RE: Grenfell Tower Fire Stopping

☐ GRENFELL TOWER REGENERATION PROJECT / RH25/RVG

The Building Regulations 2010 (as amended)  
Grenfell Tower, Grenfell Road, Refurbishment.

**Table A1 continued**

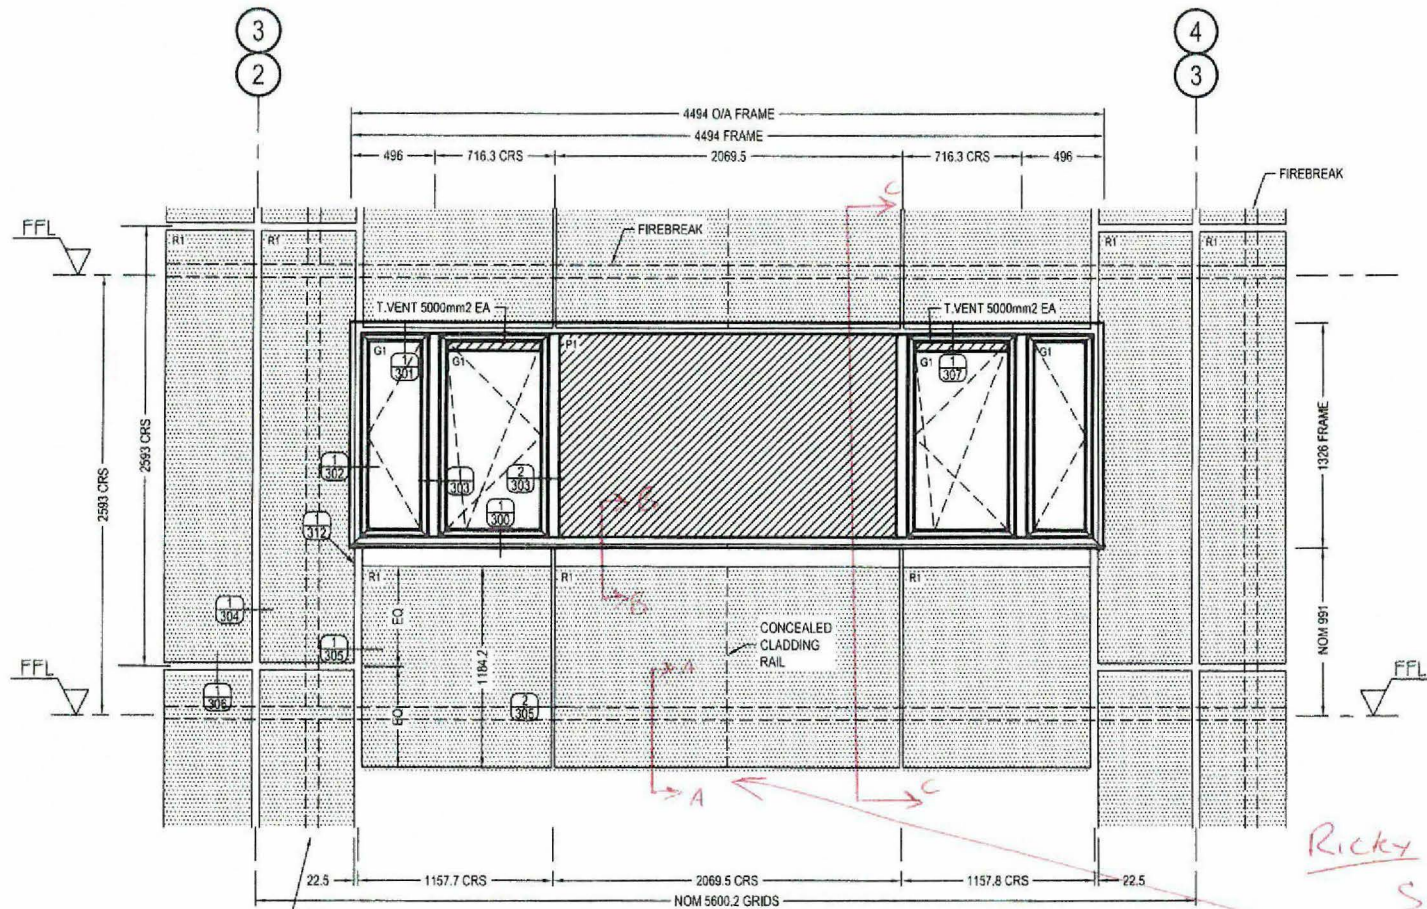
Here you can see that it clearly states that 30 minutes fire integrity and 15 minutes insulation is all that is required from a cavity fire barrier. This is reference to rainscreen cladding applications where the cavity barrier is deemed to be on the outside of the building. Our RH25-90/30 will offer 90 minutes fire integrity and 30 minutes fire insulation, therefore exceeds minimum requirements.

Drawing No: C1059-202

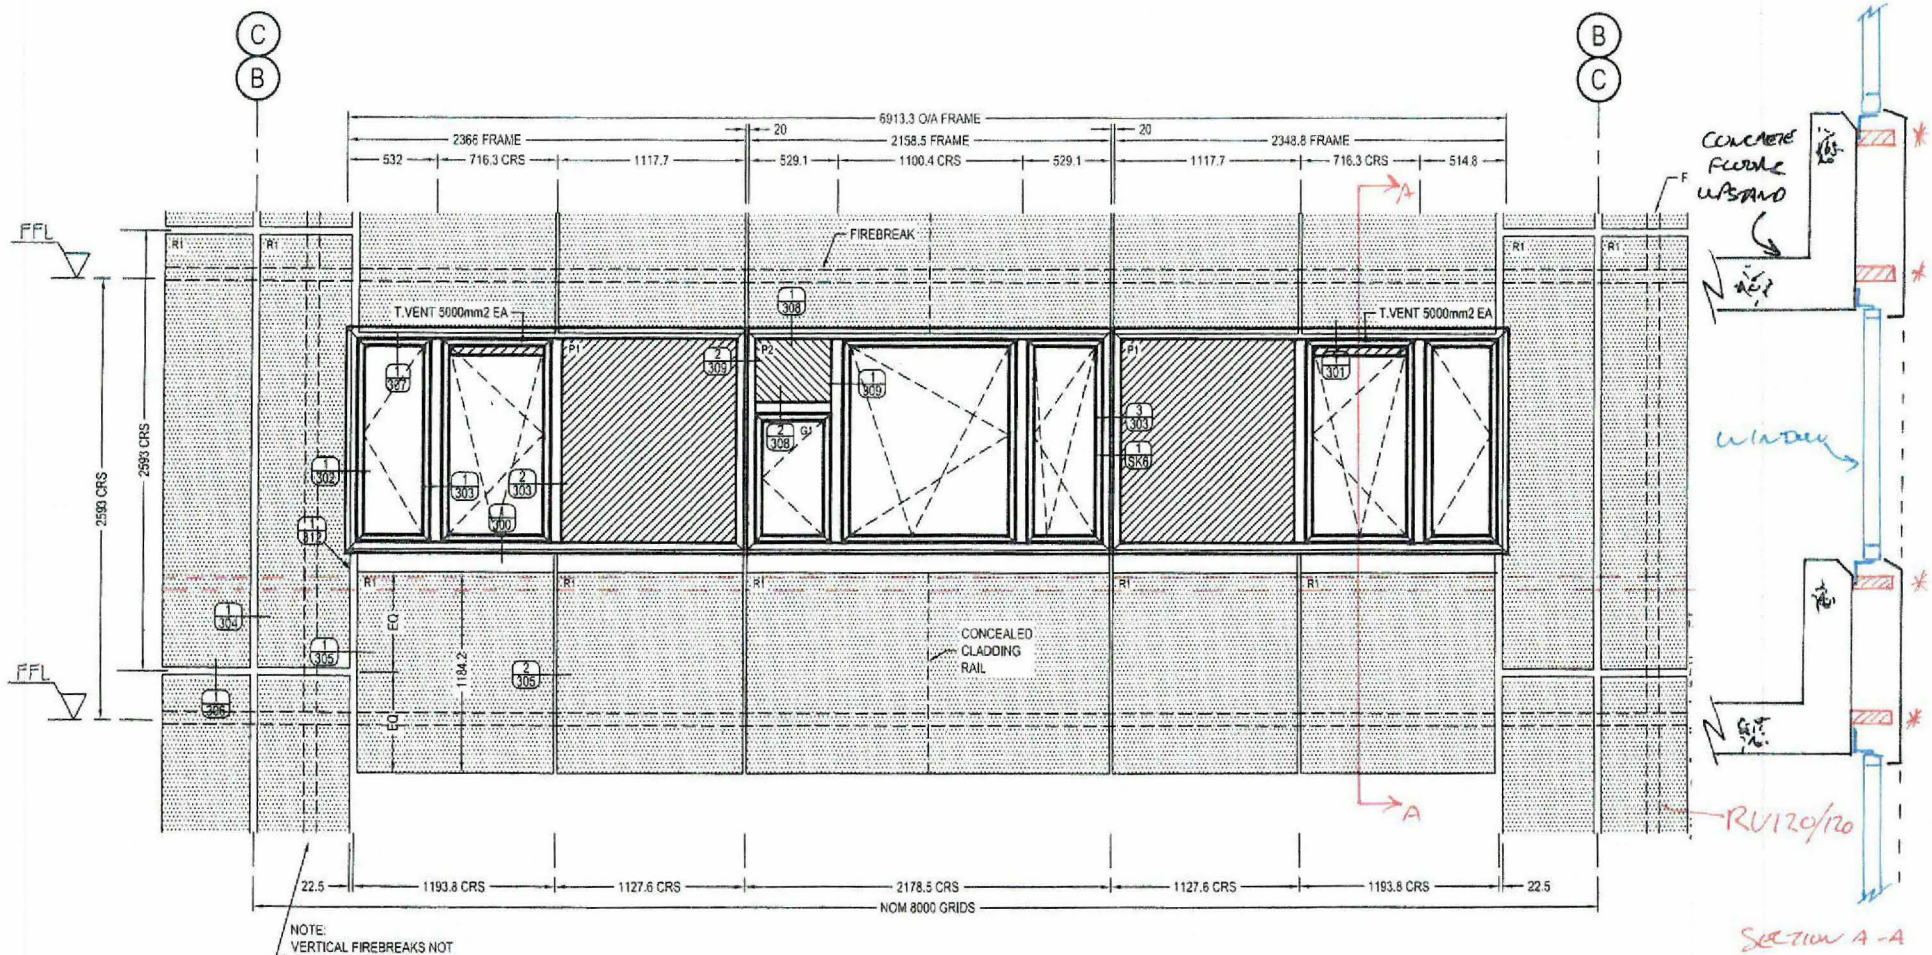
I have reviewed the drawings sent over and sketch a proposal to alleviate the issues raised by the BCO, also on the second page of the attachment I have highlighted the weak link so to speak in terms of fire and I think the BCO would have also noticed this.

The proposal requires the installation of RH25g 90/60 product in two layers one at the head of the window aligning with the compartment floor and the other at the top of the existing up stand, therefore two layers of 60 minutes protection that overall would provide if tested over 120 minutes protection, at the window locations.

*SECTIONS NEEDED  
A-A THROUGH CLADDING.  
B-B THROUGH CILL  
C-C TOTAL*

$$RH\ 256\ 90/60 \times 2 = 180/120$$
